COATES CRESCENT / ATHOLL CRESCENT

03 – COATES/ ATHOLL CRESCENTS and SHANDWICK PLACE TRAM-STOP [DRAFT as at 11 February 2008]

COMMENTS ON SDS SKETCH DESIGN

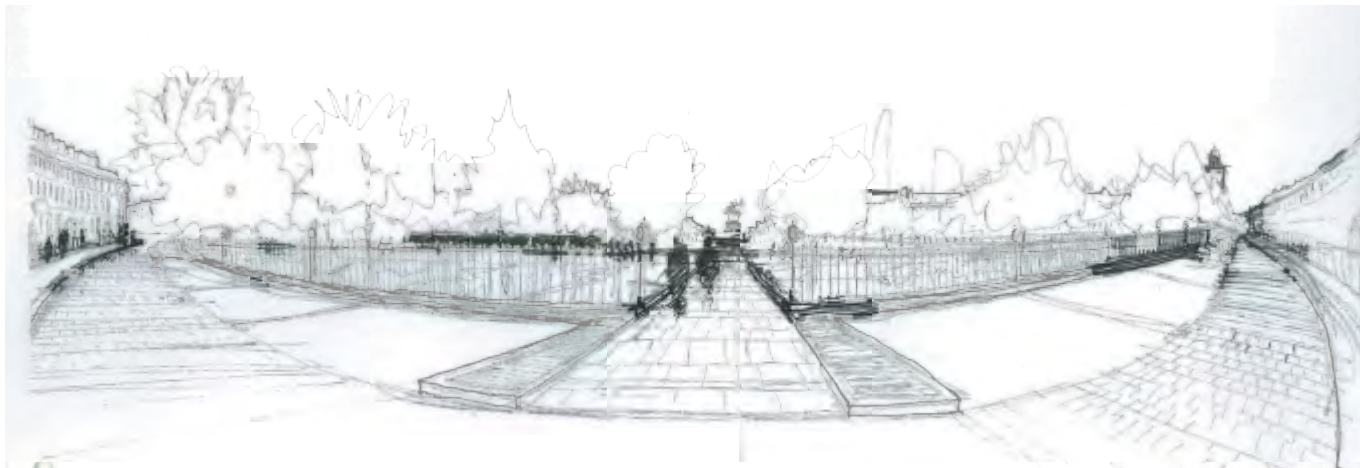
1. Treatment of Canning Street to be considered as setted surface with flush access across from Shandwick Place to Atholl Crescent? Possibility of creating a space associated with Au Bar?

2. Possibility of using one central OLE rather than two side poles in this location? Reduces clutter at pedestrian crossing, and provides more clarity at key pedestrian linking space.

3. Widen crossing to provide a better pedestrian priority in this location. Also helps to create a 'space' for the existing memorial.
4. Keep footpath consistant width in this location.

5. Potential to create two pedestrian links that relate better to the footpaths either side of Walker Street.
6. Selective removal of existing trees supplemented with planting to create 'clusters' of trees rather than one visually impermeable barrier. This would allow 'glimpse' views of the building frontages along Atholl / Coates Crescent, aiding the perception of the whole space.

7. Consideration of the axial view from Walker Street. Removal / reinstatement of planting to frame view? Consideration given to locations of OLE poles either side of the memorial?

8. Introduction of coloured tarmac through Coates / Atholl Crescent to be reconsidered. Is it necessary in a location where no cars are going to be?

▼ Possible introduction of railings within Atholl / Coates Crescent.

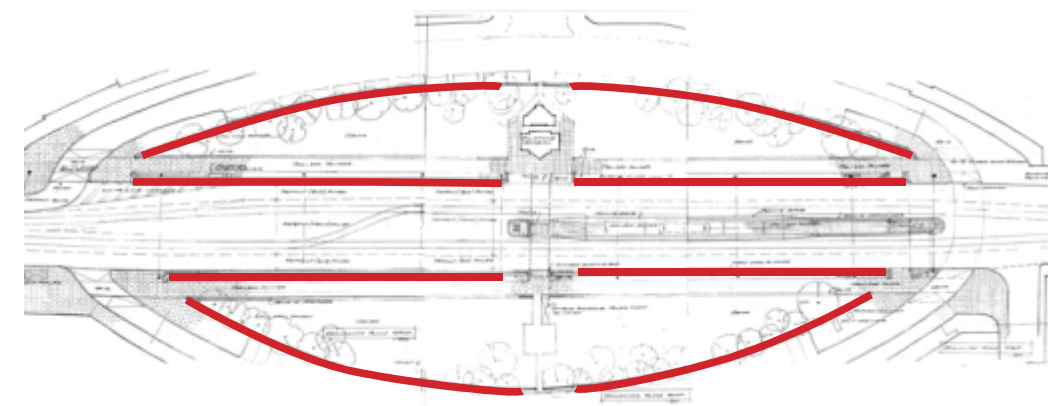
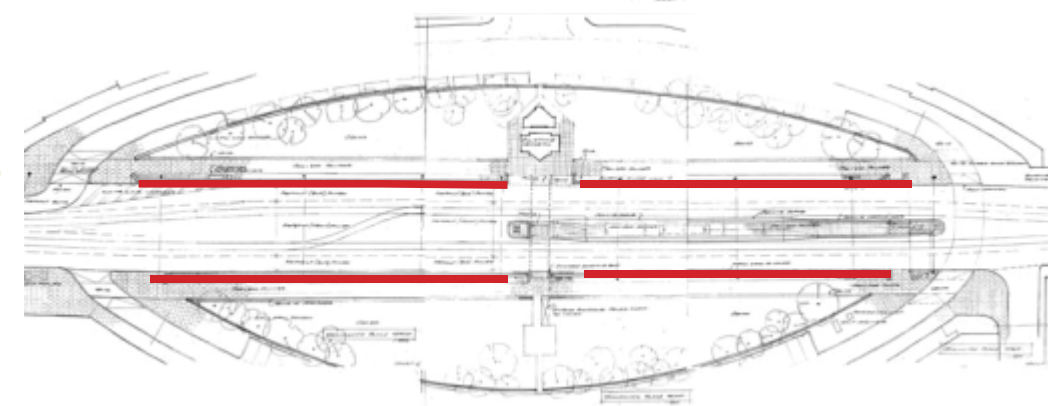
1. Railings adjacent to Shandwick Place and Atholl / Coates Crescent.
 - Experience of walking through 'gardens'.
 - Reintroduction of a historical feature.
 - Providing what is appropriate to modern uses?
 - Technical / safety issues with railings adjacent to a highway.
 - Spatial issues. Coates / Atholl Crescent visually separated?
2. Railings adjacent to Atholl / Coates Crescent only.
 - Removing vegetation along the back of the 'gardens' and reinstating the railing.
 - Visually cleaner option?
 - Spatial perception. Coates / Atholl Crescent viewed as a more cohesive space?

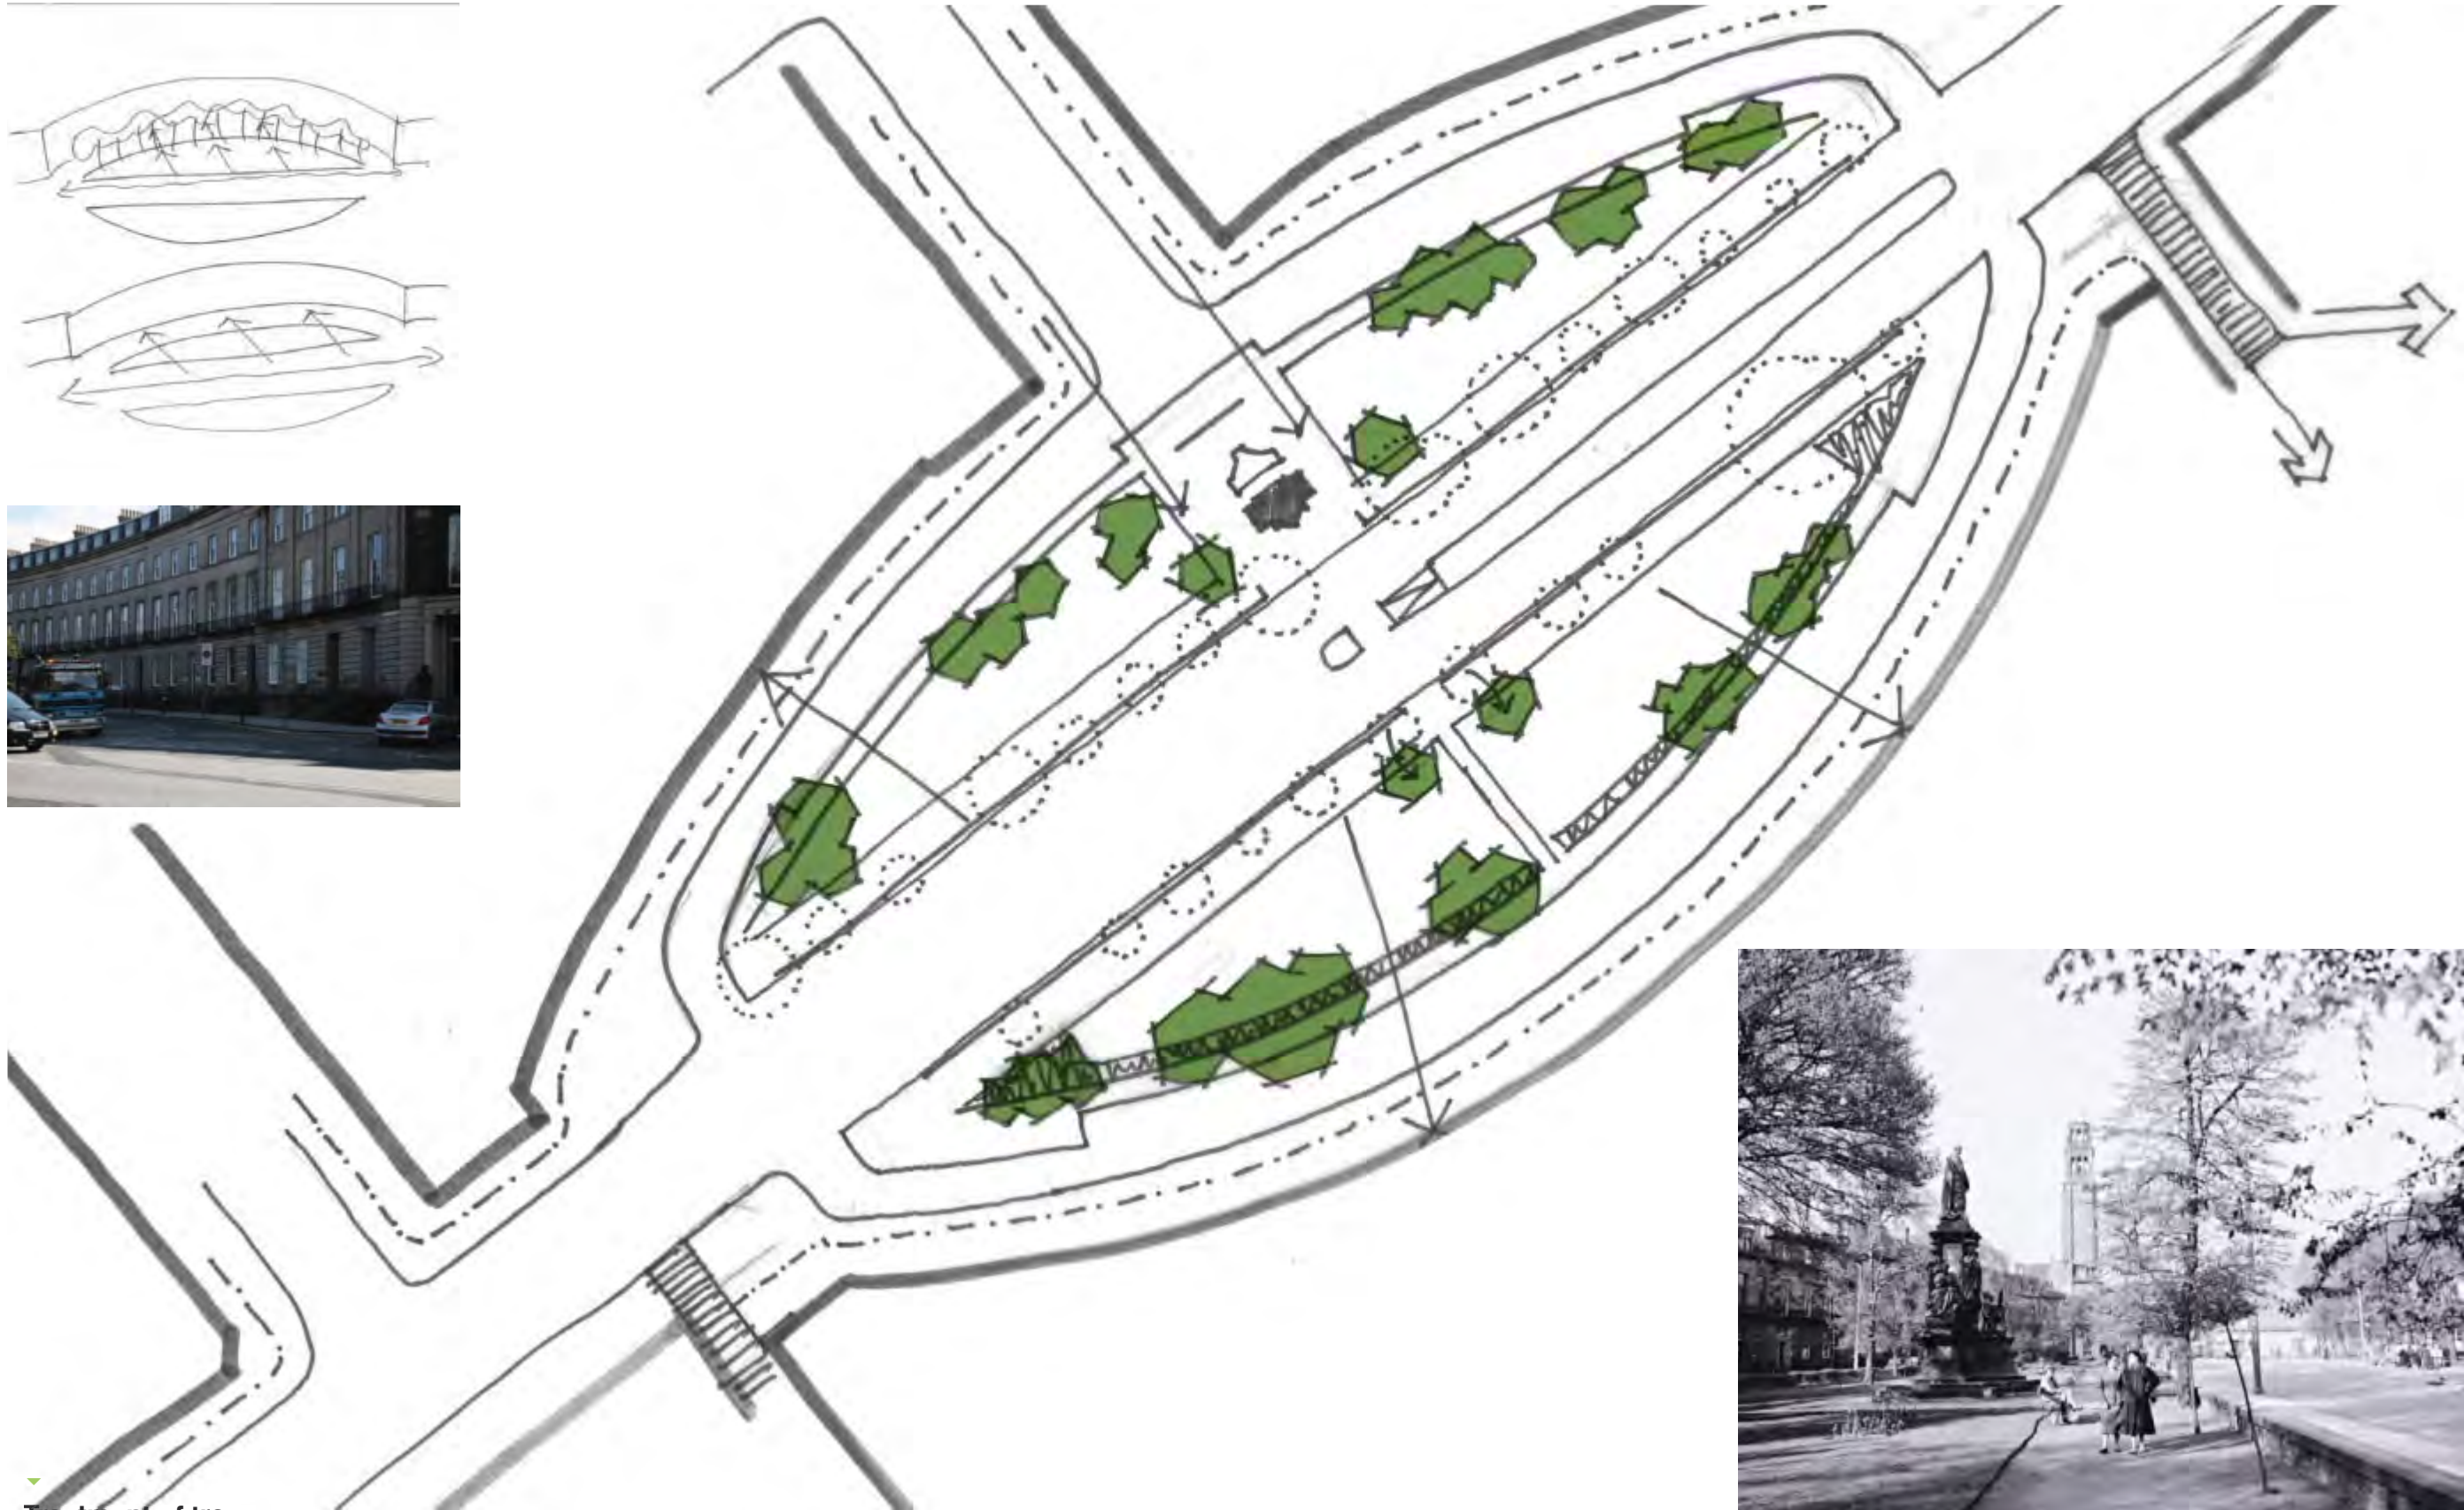
The consistent approach to materials at junctions also applies to the entrances / exits to Atholl Crescent and Coates Crescent. Flush raised tables are to be introduced with 'pedestrian' setts to the top surface.
